## Original design parameters

Dept.	Technical reference	Created by	Approv	Approved by	
		Mihaly Voroslakos			
		Document type	Document status  DWG No.		
		Title			
		metal drive v8	Rev.	Date of issue	Sheet
					1/1

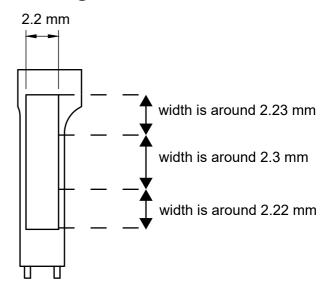
## **Printing issue**

Faulty drive

Good drive

Add the following note to the drive body: 'Use orientation as in quote 9301-742.'
